## Technical Note 001

### F/24/97945 – Response to tree officer comments

Figure 1: Magenta circles show root protection areas from earlier application

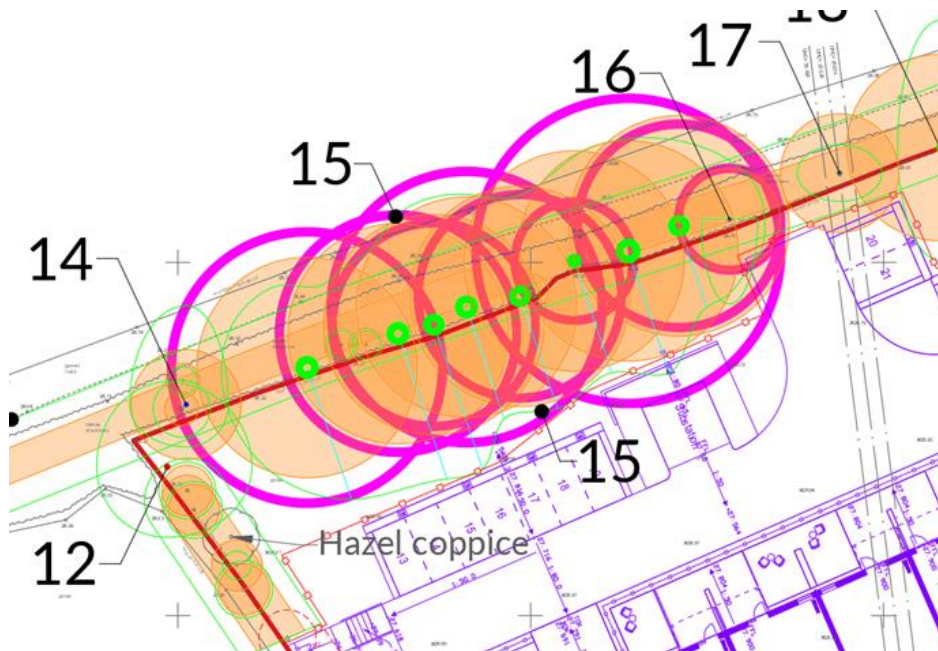
It appears from the comments that the only tree-related concern in respect of this scheme is in relation to the sub-station relative to the group of oak trees that lie along the northern boundary, close to the footpath.

The tree officer comments direct us to an earlier application for the site (taken to be F/21/89989) that had treated the group of trees as individuals. It had therefore identified individual root protection areas.

It can be seen that even if we apply the same root protection areas the current scheme is mostly outside those individual root protection areas, but the perimeter to the substation intrudes within the larger magenta circle.

The gravel perimeter that lies around the substation does extend within the outer fringes of the root protection area. The gravel margin is set above existing levels and can be achieved without the need for excavation. In essence it will be an area of permeable, no-dig surface.

Currently, the scheme shows a retaining wall along the northern edge of the gravel margin. This would require excavation for its formation. Whilst it is at the outer fringes of the root protection area, and represents a small intrusion, other options are available to marry existing and proposed levels that would avoid the excavation needed to form wall foundations.

The most suitable option is a simple grading of the earth from the edge of the gravel, down to existing soil levels. Using a soil with high sand content will provide a porous layer that will not materially alter the gaseous and aqueous exchange within the root protection area.

The perimeter to the substation, being a gravel margin, can be formed above existing levels and therefore represents no material harm to the tree. There is no need to change this aspect.

An improvement to the scheme could therefore be made by omitting the retaining wall north of the substation and replacing it with a simple soil bank.
